Form 1: Responsible Authority Report (Regulation 12)

Craft Brewery and Restaurant – Lot 201 (1248) Karnup Road, Serpentine

Form 1 – Responsible Authority Report
(Regulation 12)

2 Appropriateness of selected site, building location within the lot in context and character of the rural setting

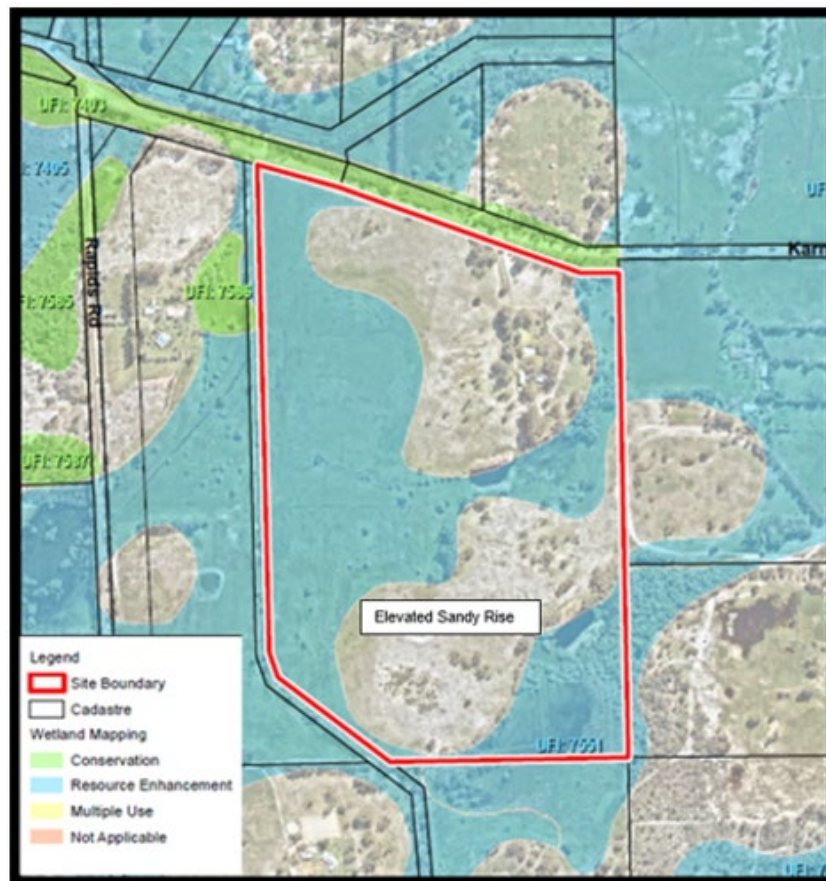
The applicant has proposed minor modifications to the development to address the concerns raised by the MODAP and community. The minor modifications are as follows:

- Restaurant and brewery structures relocated north-east of the previous location. This provides a 296m separation to the south-western property boundary, and in excess of 450m separation between the development and nearest dwelling to the south-west of the site. Approximately 420m separation is provided between the development and the nearest residential dwelling to the north-west
- Separation of the parking bays into two smaller car park areas, and incorporation of additional design features to soften the visual impact of the car parks. Approximately 300m separation is provided between the carpark and nearest dwelling to the south-west of the site. Existing screening vegetation within the southern portion of the site will be retained and enhanced with additional landscaping, significantly obscuring the view of the development from the adjoining property.

Officers are satisfied that the additional information has demonstrated that the site is suitable and the location of the buildings on the sandy rise appropriate for the proposed development to manage impacts upon rural amenity by way of management plans.

3 Location and appearance of other required structures (i.e sewage tanks) and impacts on the surrounding amenity

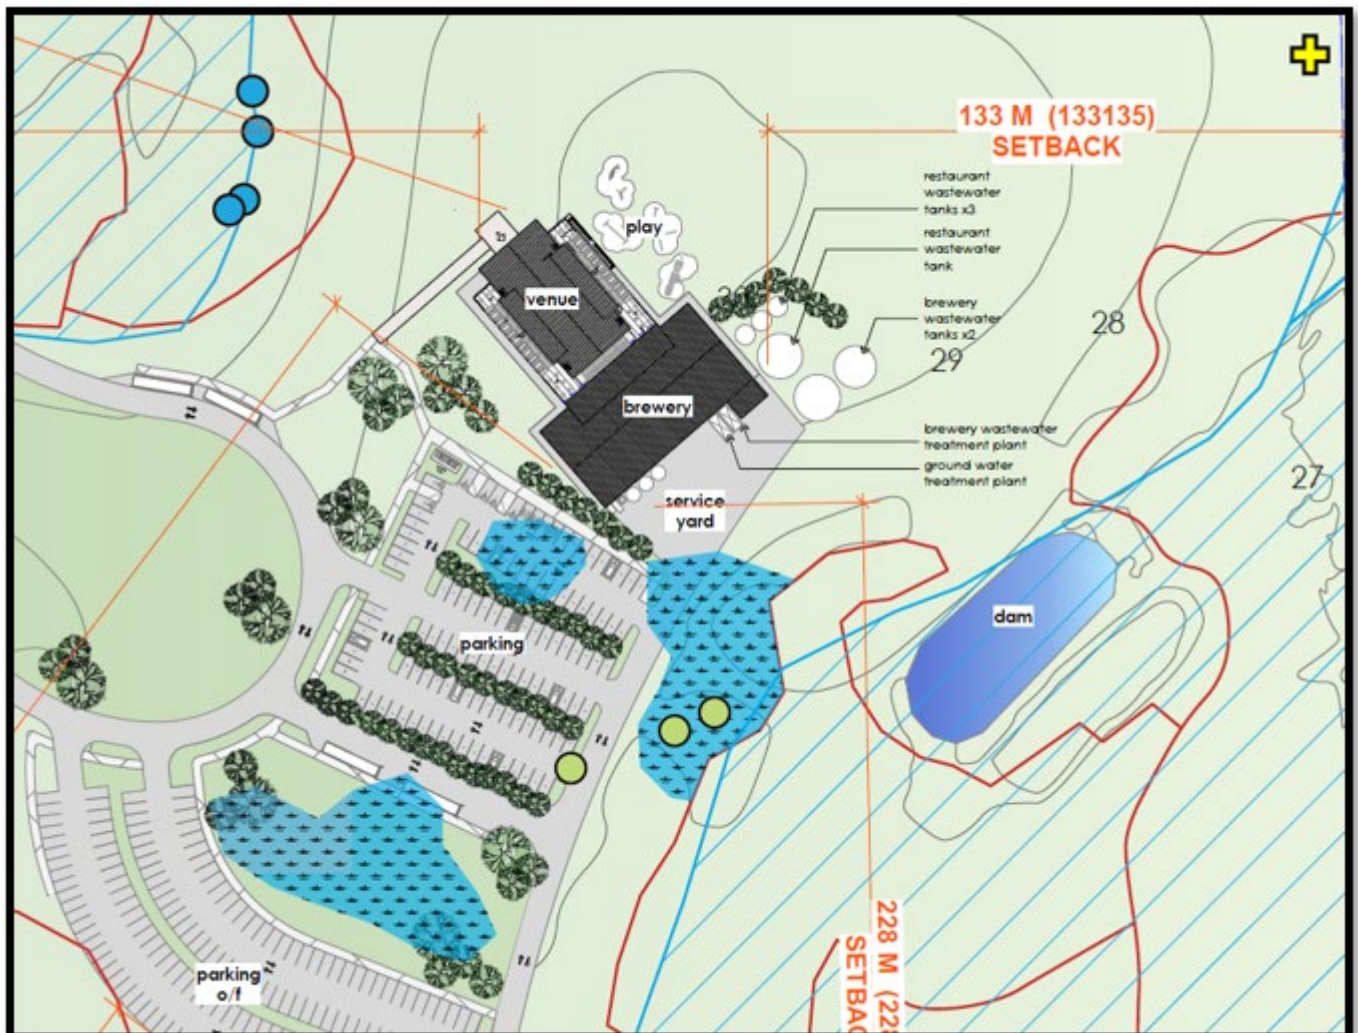
An updated site plan has been provided by the applicant depicting a range of tanks proposed to manage both restaurant and brewery wastewaters. In relation to the restaurant, four tanks have been proposed [one x steel tank 230kl 10.4m diameter x 2.9m height and three x poly tanks (corrugated) 50KL 4.6m diameter x 3.5m height].

The updated site plan also depicts the location of the wastewater treatment plant for the restaurant and brewery which is located to the rear of the brewery building.

The tanks have been located on the eastern side of the brewery and are proposed to be screened with mature landscaping. The tanks are set back more than 100m from the property boundary to the east and will be screened completely from Karnup Road. The tanks even if viewed from vistas through the proposed landscaping would appear commonplace in the setting as large tanks are a form of development typical in rural areas (water and firefighting purposes). The updated site plan can be seen in the following image in addition to images of the tanks proposed:

- iii. Wastewater storage increased onsite to cater for storage between the months of June-August based on year five volumes of production. Any above ground tanks must be screened from view at all times;
- iv. How suspended solids are removed from the wastewater system;
- v. Replace sorghum as part of the species to be planted in the irrigation areas;
- vi. How the crop will be harvested and resown;
- vii. Amend Table 7 to reflect actual total volume of wastewaters generated by the brewery for year one being 4,072 kL and Year five 8,144 kL;
- viii. Amend the NIMP to include all sources of nutrients associated with the brewery and restaurant wastewaters and demonstrate compliance with the Peel Harvey Environment Protection Policy.

7.3 ha of Irrigation Areas

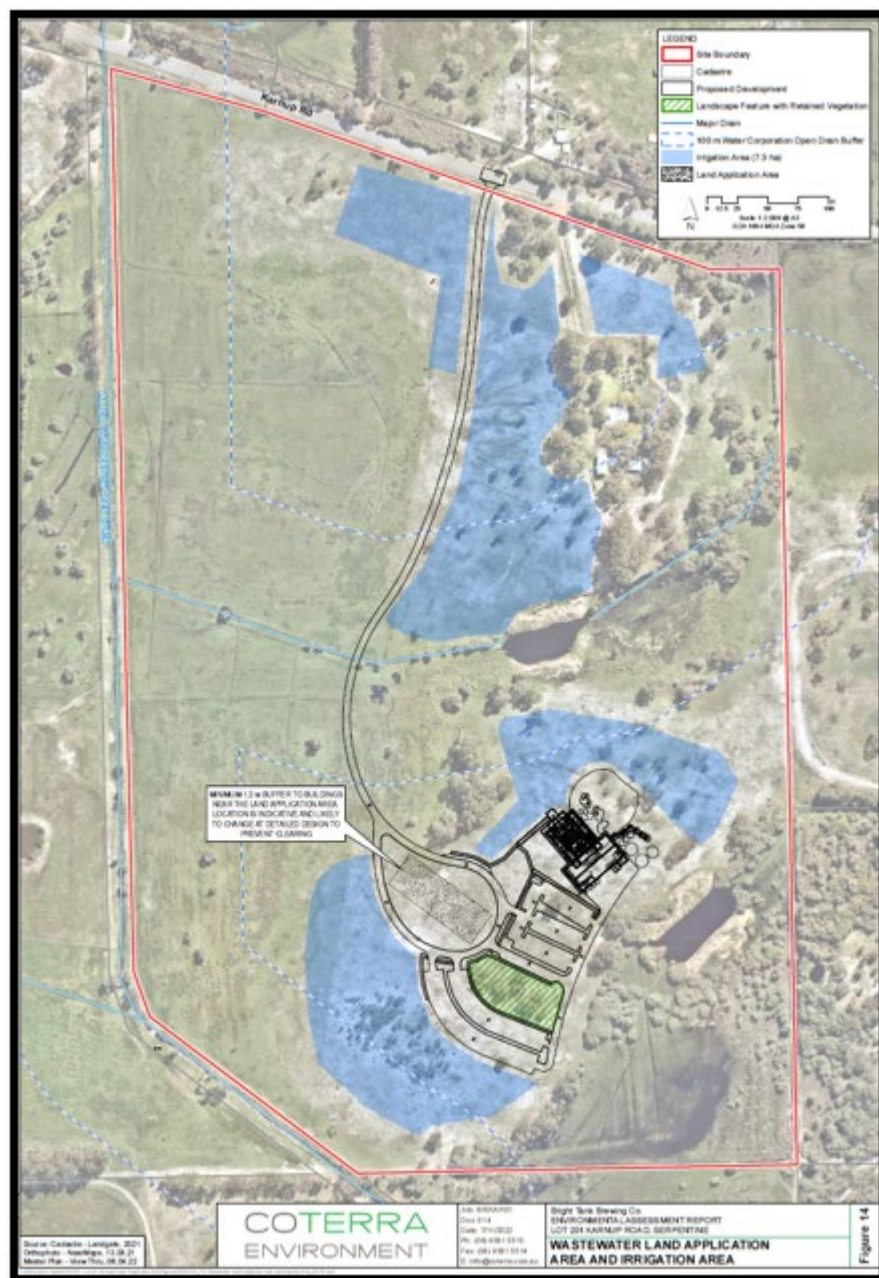
In terms of irrigation, an area of 7.3 hectares has been identified where the wastewaters once treated will be irrigated as captured below:

The area is proposed to be banded to prevent surface runoff to the low lying areas of the site which previously advised are mapped wetlands. Irrigation of the dedicated area is not proposed to occur during the months of April to September to reduce the hydraulic loading to land when rainfall exceeds evapotranspiration rates. As such, the hydraulic loading is expected to be reduced by 50% during these months. The revised NIMP indicates that approximately 234m³ of wastewater storage will be required in year one of operations (June and July periods) and 468 Kl of storage by year five.

The applicant as stated in the previous report has proposed to plant crop and pasture species, to further strip nutrients from the wastewaters once irrigated to reduce the level of nutrients leaving the site. In this regard, the applicant has proposed to plant sorghum and ryegrass within the irrigation areas. These crops have a high capacity to remove nutrient from the irrigated waters. The NIMP demonstrates that ryegrass annually can remove significant amounts of Nitrogen and Phosphorous whilst Sorghum can uptake levels of Nitrogen and Phosphorous per year. DPIRD, however, in their submission has advised that the proposed irrigation system will only suit crops with low growth height, the planting of sorghum is not suitable as a result. This will be addressed through a condition of approval replacing Sorghum as a crop to be used. The NIMP will also require to demonstrate how the crop will be harvested and resown.

- i. The 7.3 ha of irrigation area maintain a 1.5 metre separation to winter groundwater at all times;
 - ii. Any fill required to be brought to site to achieve this will be required to be clean as defined within the Department of Water Environment Regulations Landfill Waste Classification and Waste Definitions 1996 and identified on a plan;

8 Landscaping plan inclusive of vegetation clearing required

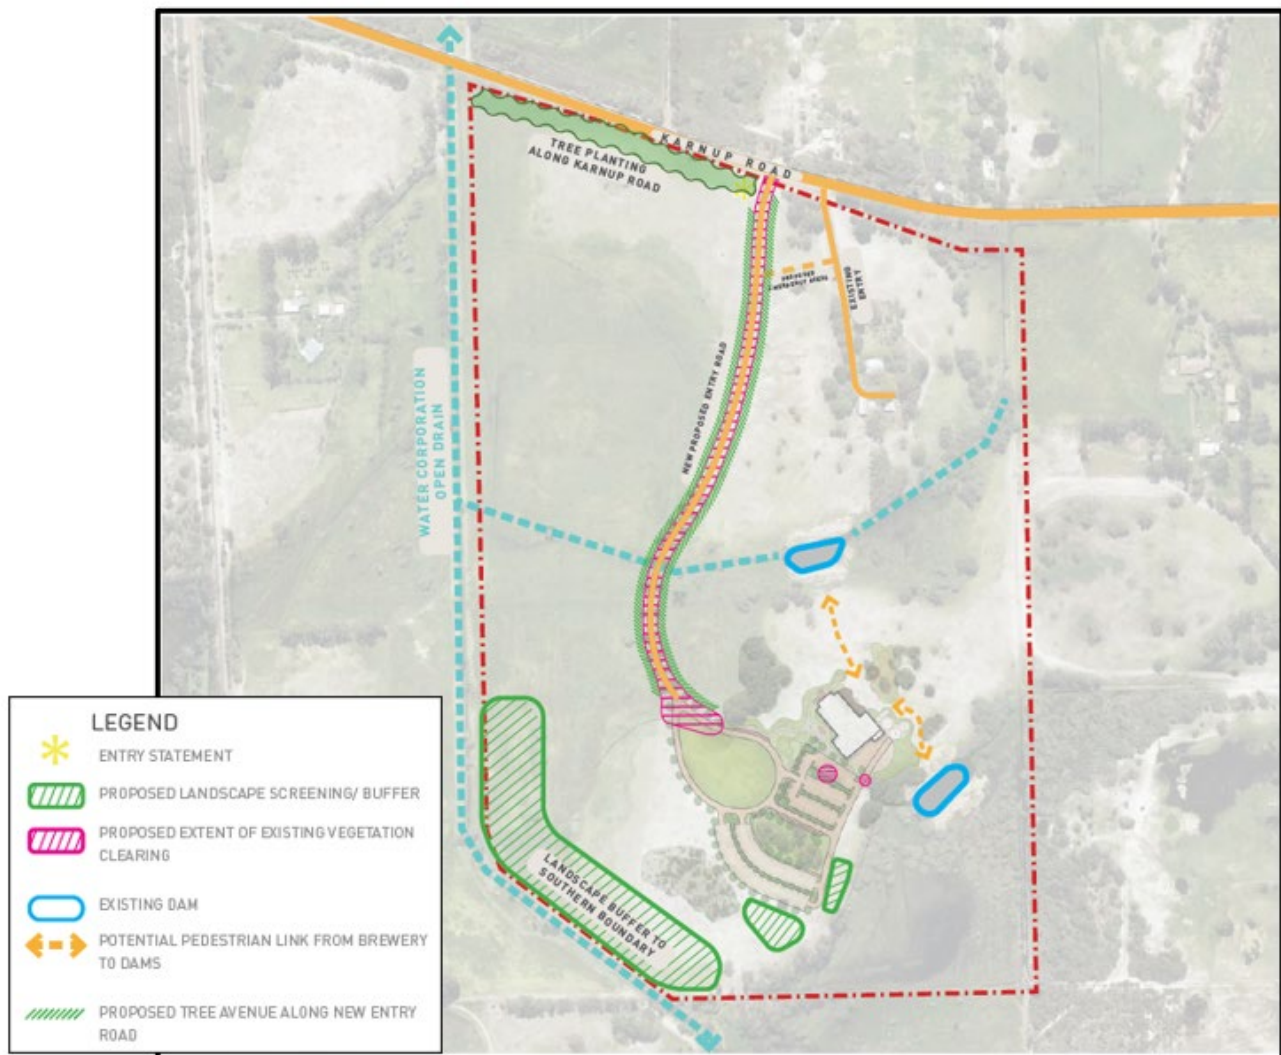
A Landscape Masterplan was prepared to detail the landscaping for the development. The landscape design was prepared to complement the features of the existing vegetation within the site. A mix of native flowering plants, substantial tree planting and a hardscape palette which reflects the rural character of Serpentine. The plan also provides for screening from vistas across the immediate area.

The submitted masterplan seeks to implement landscaping which provides for screening to the south, east and west and also to improve the visual appearance of the development. The use of native species will complement the existing natural vegetation in the immediate better reflecting the rural landscape.

In terms of clearing, the vegetation to be removed is significantly reduced from the initial 0.45ha proposed. Officers consider that the small amount to be cleared will not impact the landscape values of the site and broader locality and the proposed landscape plan seeks to replace the vegetation removed.

- m. Prior to the issue of a Building Permit, a revised Landscape Management Plan is to be submitted to the satisfaction of the Shire of Serpentine Jarrahdale for approval. The Landscape Management Plan shall incorporate mature trees where screening has been proposed to a minimum height of 1.5m. Once approved, the Landscape Management Plan must be implemented prior to the use commencing and maintained.
